**Center for Independent Experts (CIE)  
Independent Peer Review Report**

**STAR Panel Review of 2020-2021 Pacific  
Sardine Stock Assessment**

**Southwest Fisheries Science Center,  
La Jolla, California, 24-27 February 2020**

Figure 1. Bridging analysis between (a) SS version 3.24aa (2017-2019) and version 3.30.14 (2020), and (b) the model configuration (ALT) used for 2017-19 and the proposed base model for 2020. [Note: in (b), model “Add M prior” did not converge, and is therefore unreliable.]

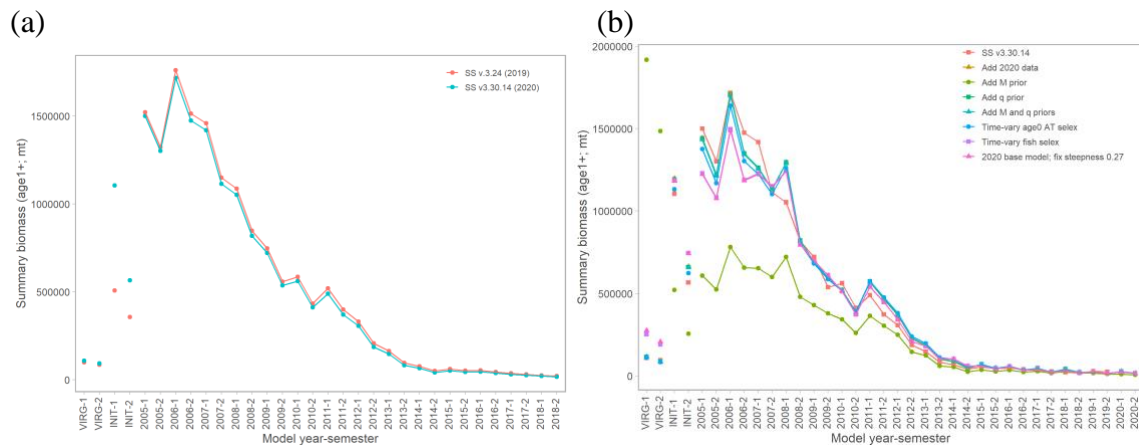
An important first step was the comparison between two versions of Stock Synthesis given the same data (Figure 1a), which showed minor differences, followed by an (almost) one-step-at-a-time bridging analysis from model ALT (used in 2017-2019) to the proposed base model (Figure 1b). The models were comparable and robust in the depiction of a strong decline of sardine biomass since the mid-2000s, and low current biomass levels. The addition of the CCPSS estimates for 2017 and 2019 to the ATM estimates (a sensitivity run not supported by

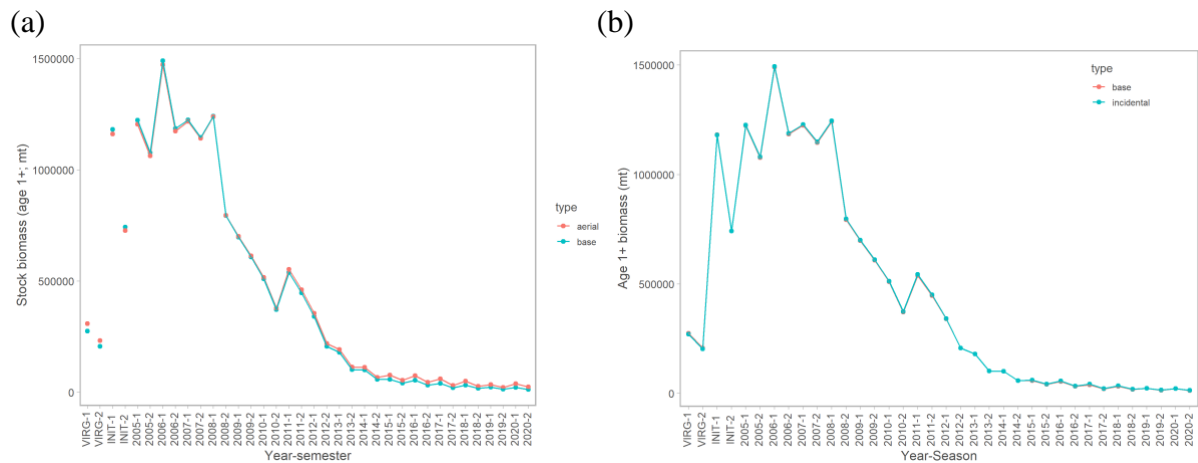
Although the methodology for assigning catches to the appropriate sardine subpopulation (northern or southern) is now well established, there remain uncertainties about this process. In particular, recent (2017-2019) Ensenada landings had to be filtered with VMS data (instead of using landing port alone) in order to exclude sardine caught south of the southern boundary of the habitat model, because a portion of the Ensenada fleet was fishing much further south than its customary fishing grounds. Request 9 compared the resultant adjustment in catches. Furthermore, no age-compositions were available for the Mexican data, and request 10 compared the length compositions from Ensenada with those from southern and central California but found these data to be variable rather than systematically different. Age compositions for incidental catches (INC), largely from the MexCal region, are available from 2015 onwards, and request 1 considered these. A sensitivity run was presented that included these INC data, but results showed their inclusion had little impact (Figure 2b).

the Panel in the way it was done) showed an almost doubling of current biomass, from 22301 mt to 37276 mt (Figure 2a).

Figure 3. Likelihood profile on  $R_0$  for the proposed base model. [Note the SR Regime parameter (*initEQ\_Regime*) is highly influential, which was not the intention.]

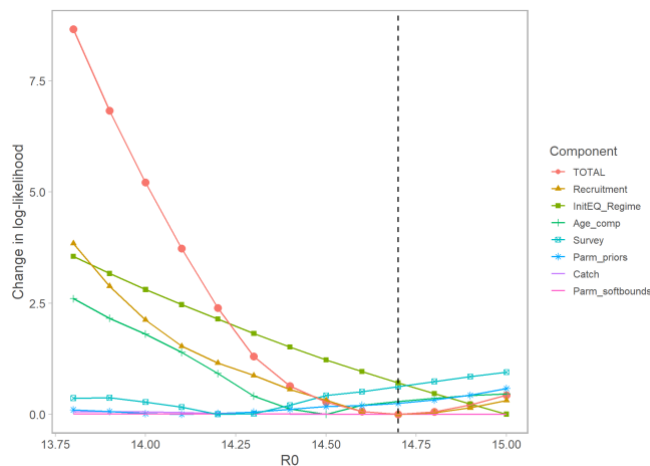
When the panel was inspecting the diagnostic plots for the proposed base run (model A), it became clear that the SR regime parameter (the R1 offset) was not behaving as it should, because it had unexpected influence on the total likelihood (Figure 3); both the Panel and STAT were unclear how this parameter was defined, and additional model runs either did not estimate the parameter (model B1), or removed it from the likelihood by setting the corresponding  $\lambda$  in the likelihood to zero (model B2; request 14). This meant, however, that steepness was no longer estimable (model C1; request 16) and was instead fixed at 0.3 (model C2), close to the value in previous models when it was still estimable.
